EPA Region 8
Underground Injection Control (UIC) Program
Response to Public Comments

Class III Area Permit No. SD31231-00000, Aquifer Exemption Decision
And
Class V Area Permit No. SD52173-00000

Powertech (USA) Inc.
P.O. Box 448
Edgemont, South Dakota 57735

Final Permit issuance: November 24, 2020

Figure A. Gott et al., 1974, Plate 2 showing the extent of the Dewey Fault and Structural Zone with the Dewey-Burdock Project Area superimposed.

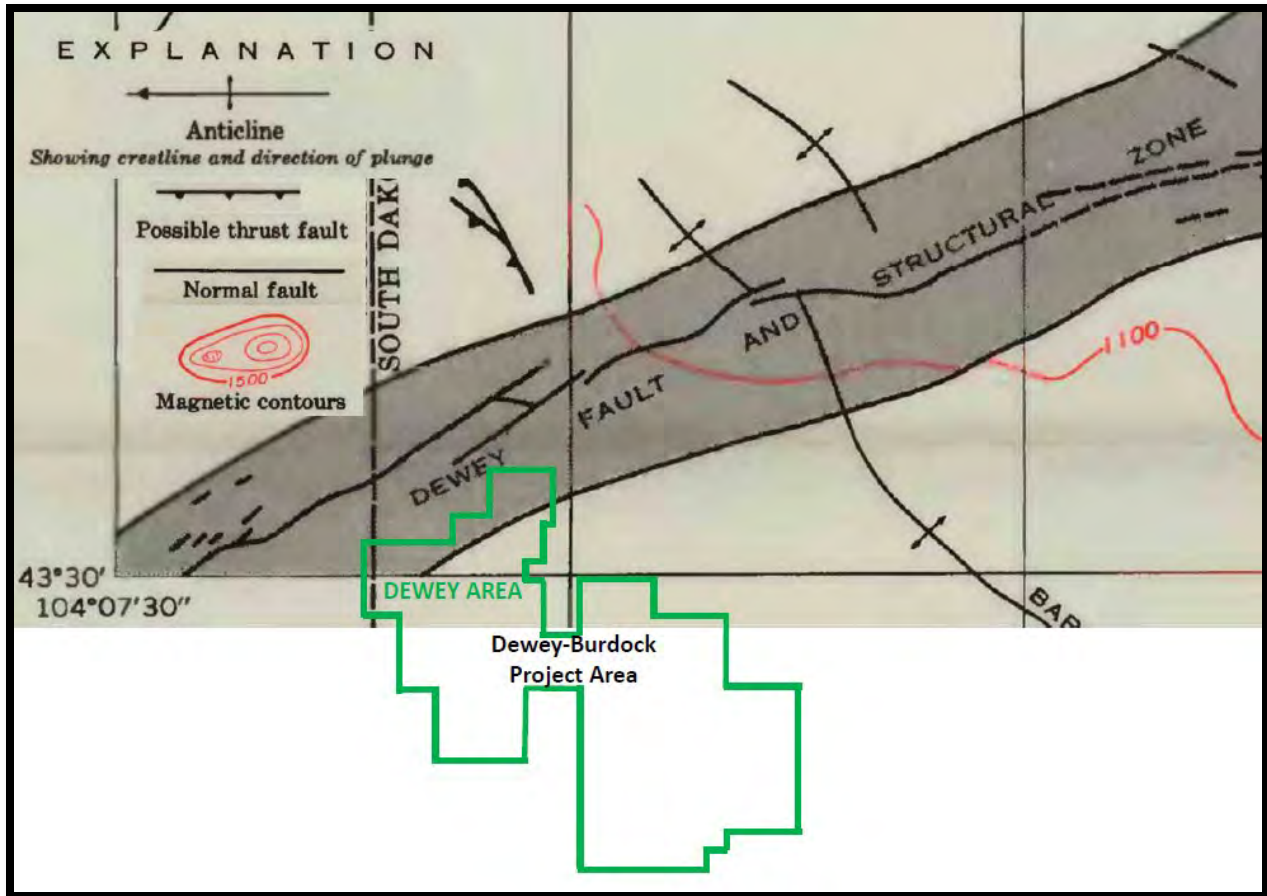
A commenter referred to Plate 4 from Gott et al., 1974, as the Gott fault map. Powertech used Plate 4 as a base map for Plate 6.24 of the Class III Permit Application and superimposed the Dewey-Burdock Project Boundary to show where the collapse features and breccia pipes identified in Gott et al., 1974, are located relative to the Project Site. Plate 6.24 shows that none of these features are located inside the Project Area. Figure B is an excerpt from Plate 6.24. The features shown inside the project boundary are Beaver Creek and paleostreams. The linear feature in the red box inside the Dewey-Burdock Project Area is the southeast boundary of the Dewey-Fault and Structural Zone shown in Plate 2.

There is no evidence of the Dewey fault inside the project area. (Brobst, 1961, *Geology of the Dewey Quadrangle Wyoming-South Dakota*, USGS Bulletin 1063-B.) Brobst, 1961, describes the Dewey Fault in the Dewey quadrangle geologic report as the fault passing through the town of Dewey and refers to the fault located to the southeast without a name. Braddock, 1963, does not refer to more than one fault plane related to the Dewey Fault in the Geology of the Jewel Cave SW quadrangle report (Braddock, W.A., 1963, *Geology of the Jewel Cave SW quadrangle Custer County, South Dakota*, USGS Bull 1063-G). Gott, et al., 1974, includes both faults described by Brobst, 1961, in the Dewey Fault and Structural Zone. The boundaries of this structural zone are shown in Plates 2 and 4 of the Gott et al., 1974 report. The extent of the Dewey Fault and Structural Zone as defined by Gott in Plate 2 near the Dewey-Burdock Project Site is shown in Figure A. The Dewey-Burdock Project Site Boundary is superimposed on Plate 2. Although Gott shows the Dewey Fault and Structural Zone as extending into the northwestern edge of the Dewey-Burdock Project Site, there is no evidence of any fault inside the Project Area.

Figure E. Areas of the Inyan Kara Group aquifers approved by this Record of Decision.

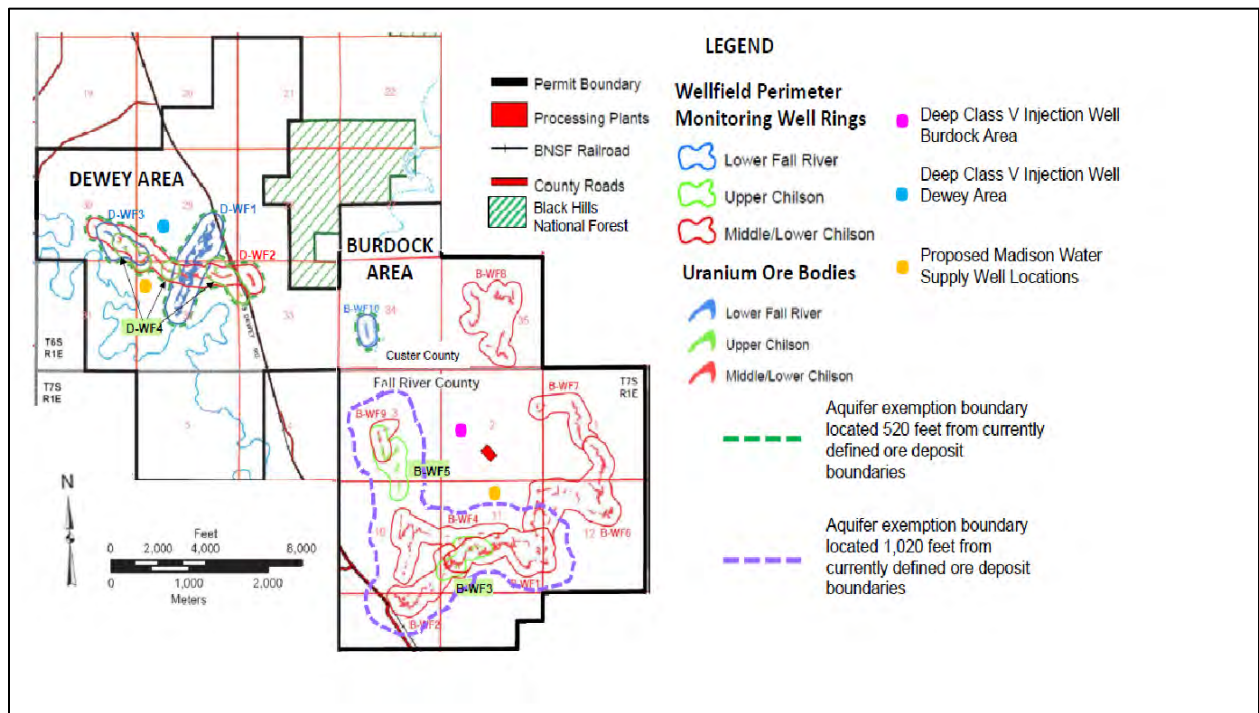
Powertech requested an expanded AE area to accommodate additional ore resources identified after the Class III Permit Application was submitted. EPA reviewed the Preliminary Economic Assessment reports developed by consultants documenting independent audits of mineral resource estimates at the Dewey-Burdock Project Site and determined that the commercially producible ore resource boundary had expanded in Burdock Wellfields 1 through 5, 9 and 10 since Powertech submitted the Class III Permit Application, justifying expanding the AE boundary for these wellfields. However, the commercially producible ore resource boundaries had not expanded for the other wellfields, so EPA did not expand the AE boundaries for these other wellfields. Because Powertech needs to do additional work to demonstrate that the potentiometric surfaces in Burdock Wellfields 6, 7 and 8 are able to sustain adequate monitoring of ISR operations in the overlying Upper Chilson aquifer, EPA is postponing approval the aquifer exemption in the area of Burdock Wellfields 6, 7 and 8 until Powertech performs further aquifer testing in that area.

original AE boundary proposed by Powertech in the Class III Permit Application. The blue dashed line is the expanded AE area Powertech requested after the first draft Class III Area Permit was issued.

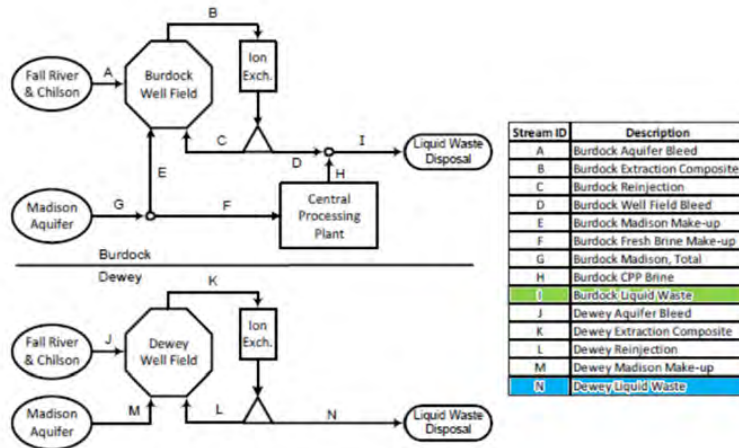
275. Powertech states that in the first paragraph in this section, the statement is made that “Powertech estimates that typical liquid waste flow rates during groundwater sweep under the land application option during aquifer restoration will be approximately 507 gpm as shown in Table 5, Section 3.1.2 of this document.” Powertech states that similar to the last comment, the reference to Section 3.1.2 is for estimated Madison usage, not wastewater disposal requirements under the land application option. Powertech explains

that Figure 7.1 of the Class III permit application and Table 5.3-2 of the Large Scale Mine Permit Application show that the maximum anticipated liquid waste flow rate during concurrent operations and aquifer restoration under the land application option is 582 gpm. Powertech requests correcting this statement as follows:

EPA agrees with Powertech's proposed changes in this comment and has made edits in the CEA as Powertech proposes in this comment. The 582 gpm flow rate is derived by adding up the waste stream flows from Figure 7.1 of the Class III permit application. The 582 gpm flow rate is the total of Burdock Liquid Waste (Stream ID I) during the uranium recovery phase for the land application disposal option (54 gpm), plus Burdock Liquid Waste (Stream ID I) for the Restoration phase, with Groundwater Sweep, land application disposal option (250 gpm) outlined in green in the Figure S below, plus Dewey Liquid Waste (Stream ID N) during the uranium recovery phase for the land application disposal option (28 gpm), plus Dewey Liquid Waste (Stream ID N) for the Restoration phase, with Groundwater Sweep, land application disposal option (250 gpm) outlined in blue in the Figure S below. Those numbers add up to 582 gpm.

Figure 3.2-6: Overall Process Flow Diagram

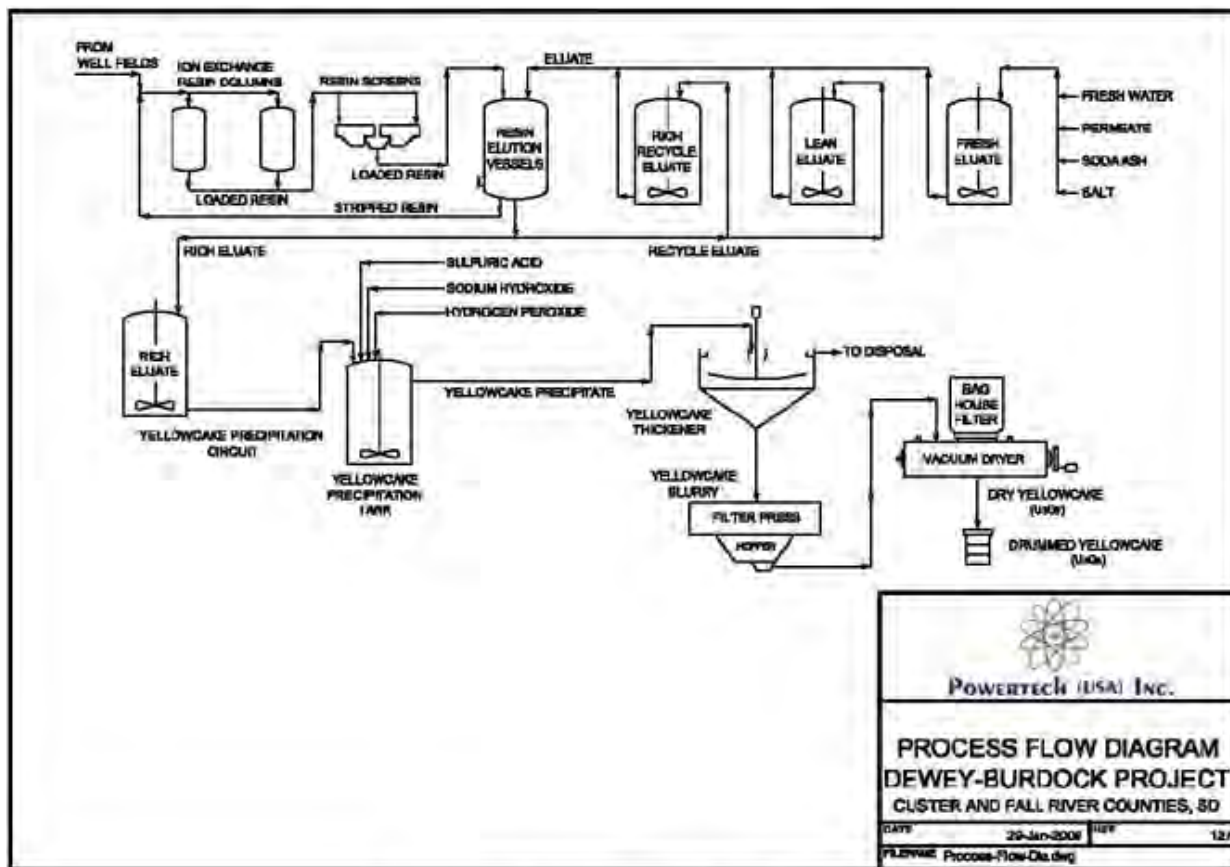
361. Powertech raises a comment regarding the statement in the CEA that Powertech proposes to store, use, and receive shipments of anhydrous ammonia (NH₃). According to Powertech, it does not propose to use ammonia at the Dewey-Burdock Project. Powertech refers to Figure 3.2-6 in the approved NRC license application and explains that it shows that sodium hydroxide will be used in the precipitation circuit instead. Powertech also refers to Table 3.2-1 in the approved NRC license application, which lists the process-related chemicals and quantities planned for the project, likewise does not include ammonia. Powertech requests removing mention of anhydrous ammonia from this paragraph.

EPA agrees with Powertech’s comment and has updated the two references to “anhydrous ammonia” (NH₃) in the CEA Section 12.2, and instead replaced them with sodium hydroxide. We have included Figure 3.2-6 in the approved license application here.
